ECN/PCN No.: 4331

For Manufacturer			
<b>Product Description:</b> 32.768kHz SMD Low ESR Crystal	<b>Abraccon Part Number / Part Series:</b> ABS07-LR	<input type="checkbox"/> Documentation only <input checked="" type="checkbox"/> ECN <input type="checkbox"/> EOL	<input checked="" type="checkbox"/> Series <input type="checkbox"/> Part Number
<b>Affected Revision:</b> B	<b>New Revision:</b> C	<b>Application:</b>	<input type="checkbox"/> Safety <input checked="" type="checkbox"/> Non-Safety

Mechanical Dimensions:

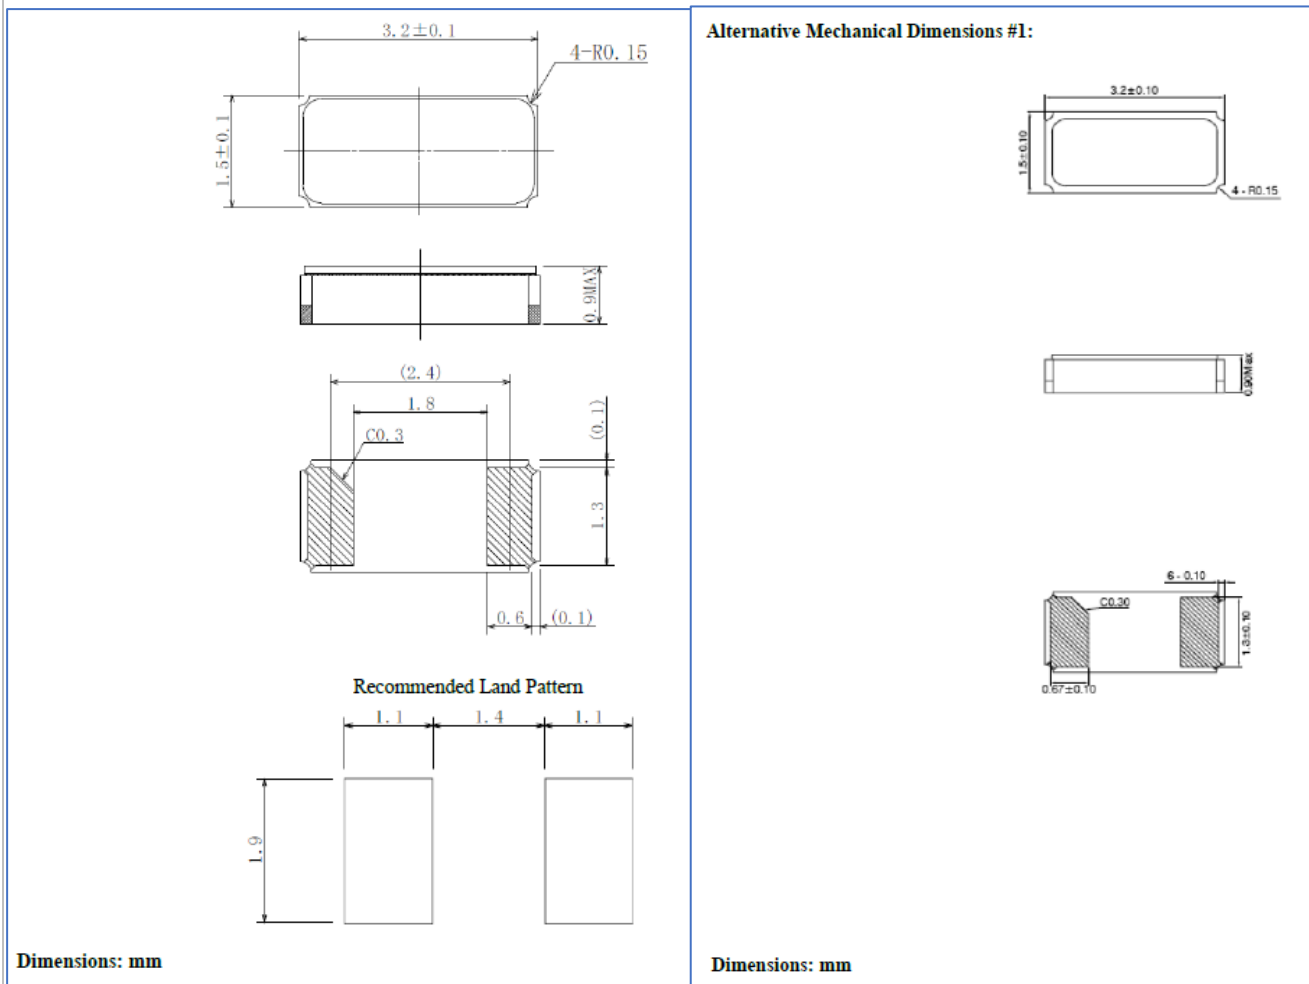
- Added Alternative Mechanical Dimensions #1

Abracon introduced additional manufacturing sources to ensure product availability and to be in a better position to meet long term customer demand. Added an alternative bottom packaging structure to reflect the product produced by all manufacturing sources.

**Change Declaration:**  
The added bottom packaging structure does not impact the electrical performance of the device.
